Air Pollution Control
Title V Permit to Operate
Draft Permit No. V-UO-000004-00.00
Draft Initial Part 71 Permit

Deseret Power Electric Cooperative
Bonanza Power Plant
Uintah and Ouray Reservation
Uintah County, Utah

Statement of Basis

Figure 1.[42]

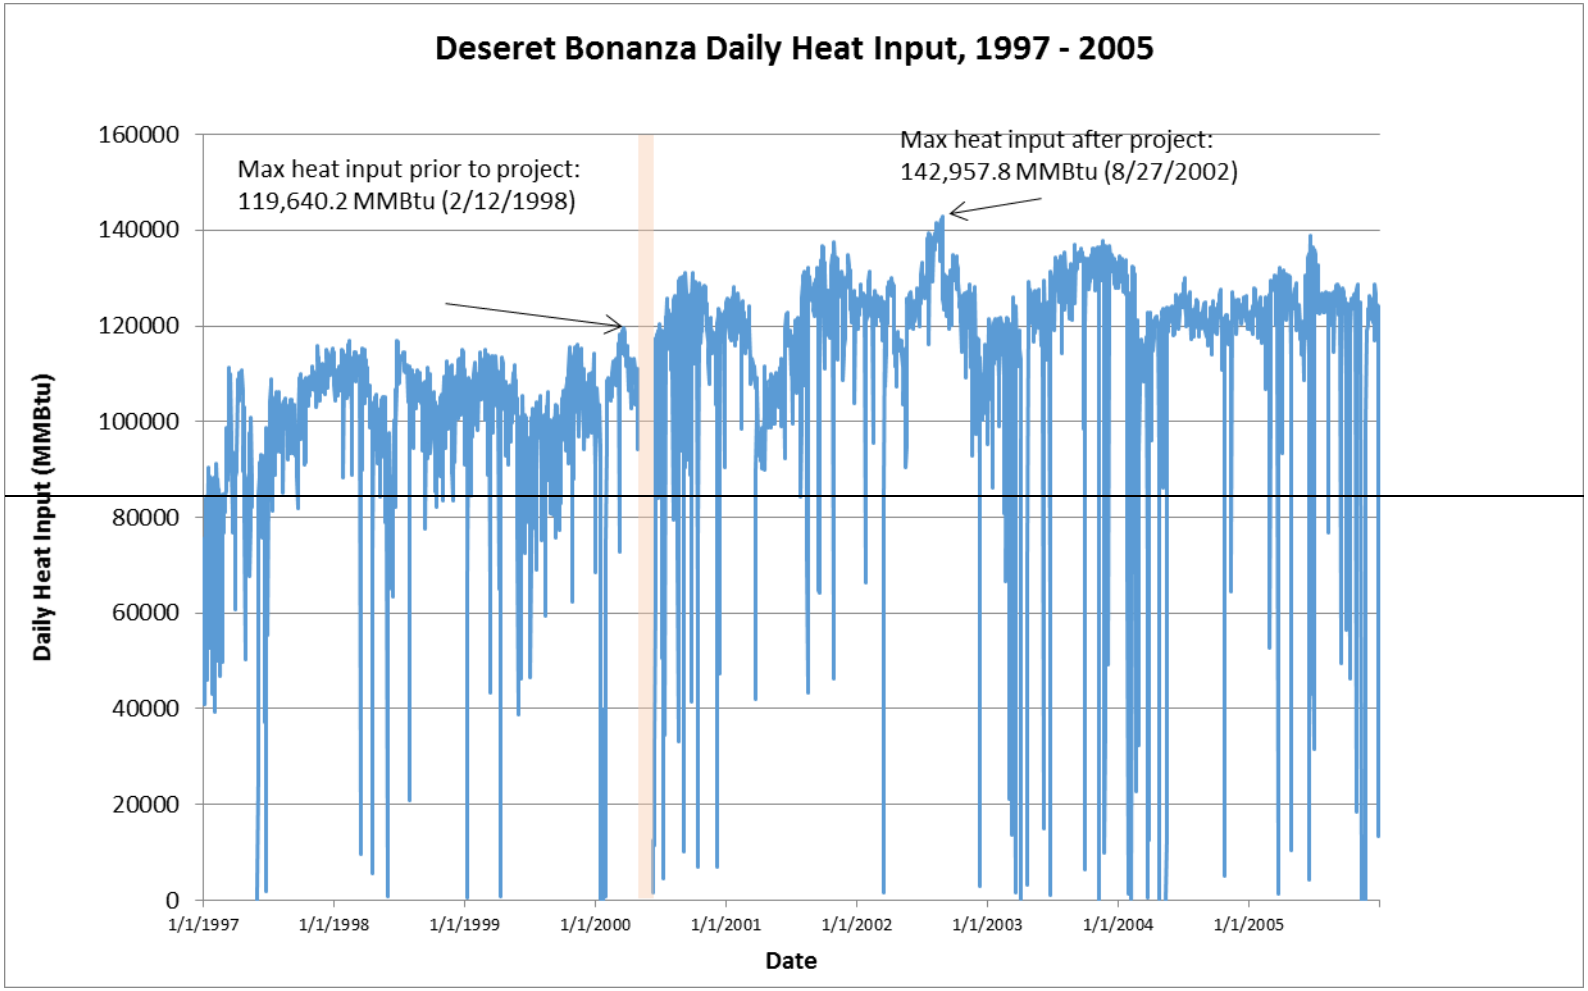
EPA has examined daily actual heat input data on the Bonanza power plant from 1997 through 2005, in an attempt to evaluate the extent to which an increase in actual heat input capacity may have occurred and been utilized as a result of the ruggedized rotor project.[32] Results are presented in Figure 1, at page 52 below. For example, if one compares the pre-project daily actual heat input values with post-project daily actual heat input values, then it appears that actual post-project heat input has, in fact, been in excess of the plant's pre-project capacity.[33] Prior to the project, the maximum actual daily heat input was 116,940 MMBtu, while after the project the maximum actual daily heat input was 142,958 MMBtu. Moreover, following the project, the actual daily heat input exceeded the pre-project maximum of 116,940 MMBtu on most days. When considered

[33] Daily heat input data obtained from the Air Markets Program Data and based on the procedures found in 40 CFR Part 75, Appendix F. Refer to Figure 1 of this document.
